ABBREVIATED PLAT AGENDA

May 22, 2024

**STAFF REVIEW AND RECOMMENDATIONS
PUBLIC HEARING
MAY 22, 2024**

PRELIMINARY PLAT: KNIK HEIGHTS 2024

PLAT OF
KNIK HEIGHTS 2024
A SUBDIVISION OF LOT 2, BLOCK 3, KNIK HEIGHTS SUBDIVISION,
PLAT No. 2003-117, PALMER RECORDING DISTRICT,
THIRD JUDICIAL DISTRICT, STATE OF ALASKA
LOCATED WITHIN
SW 1/4 OF SECTION 5, TOWNSHIP 16 NORTH, RANGE 2 WEST,
SEWARD MERIDIAN, AK
CONTAINING 5.005 ACRES, MORE OR LESS.

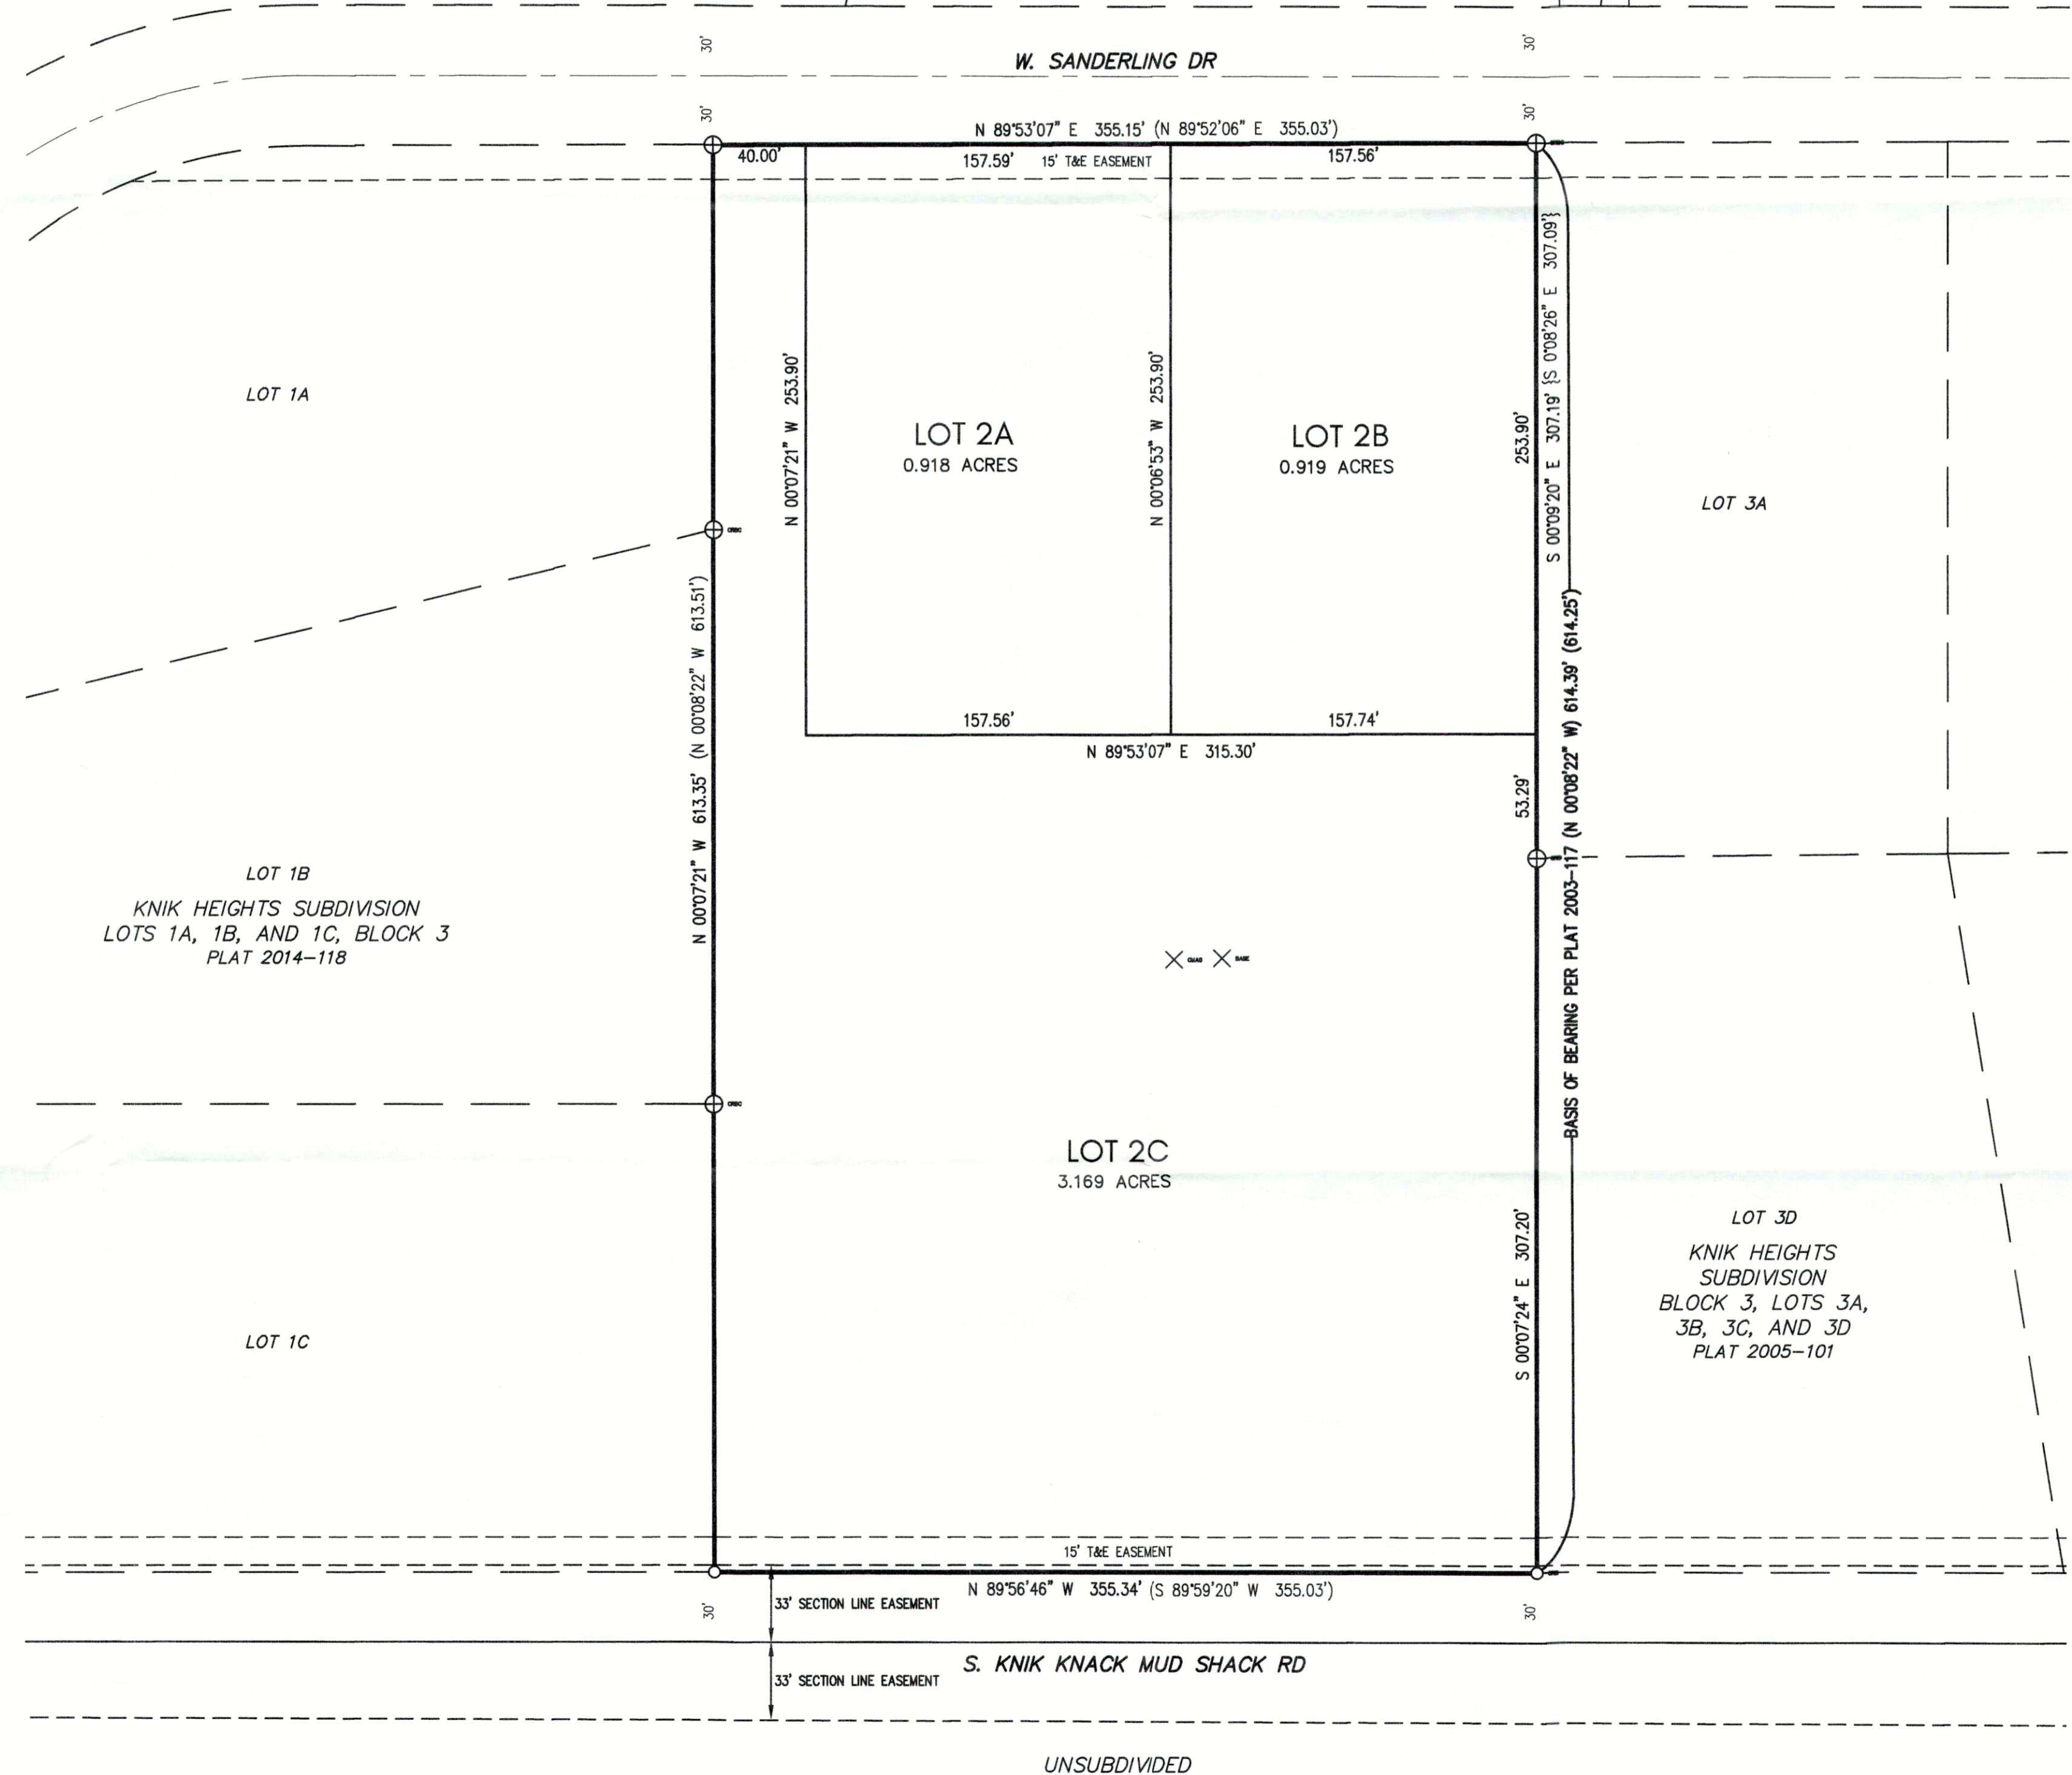
Division of Development Services (**Exhibit F**) notes that the driveway on proposed parcel 2B does not have a permit on file (see **Recommendation #1**).

Lot Design: The existing design shows a 40' flag pole as part of Lot 2C. Lot 2C is larger than 3 acres and this flag pole portion must be a minimum of 60' wide and redesigned (see **Recommendation #2**) to comply with MSB 43.20.300 (E)(6) *Lot and Block Design*.

Good afternoon, Natasha. The property owners will need to apply for a driveway permit for the driveway on the eastern half of the parcel:

This property has a second driveway that does not have a permit on file, please have your applicant apply for their permit.

1. Obtain a driveway permit for existing driveway on Lot 2B per comments from MSB Development Services Division. Provide copies of applications and/or existing permits for driveways on both Lot 2B and 2C.

2. Adjust the lot design to comply with MSB 43.20.300 (E) *Lot and Block Design*. Changes could include either increasing the pole portion of Lot 2C to a minimum of 60' per MSB 43.20.300 (E)(6)(b), or reducing the lot size of Lot 2C to three acres or less to maintain the 40' wide pole portion per MSB 43.20.300 (E)(5)(b).
